Work Order ID 69364

Item Name: Crosstube Aft

DRAWING NO. D412-664-243	TITLE CROSSTUBE ASSEMBLY (412 HI AFT)	REV. E	DART AEROSPACE LTD ENGINEERING ORDER		D.E.O. NO. D412-664-243-E-1	SHEET NO. SHEET 1 OF 2	SCALE NTS
DRAWN	CHECKED	MFG. APPR.	APPROVED	DE APPR.			
DATE 11.03.31	DATE 11/03.31	DATE 11.03.31	DATE 11/03.31	DATE 11.03.31

REMOVED ABRASION STRIP IN FAVOR OF A THIN LAYER OF PROSEAL 890.

**D412-664-243
ASSEMBLY DETAIL**

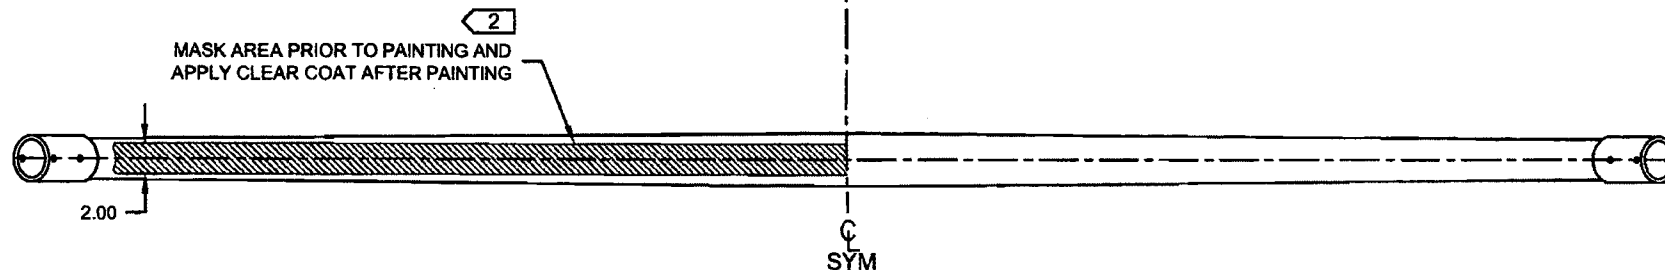
IS:

D3189-1 CHAFING SHIELD (1, INSTALLED OVER PROSEAL 890)
MS21920-28 CLAMP, 2X
2 PL

WAS:

D2858-600-1009 ABRASION STRIP
D3189-1 CHAFING SHIELD (1, INSTALLED OVER ABRASION STRIP)
MS21920-28 CLAMP, 2X
2 PL
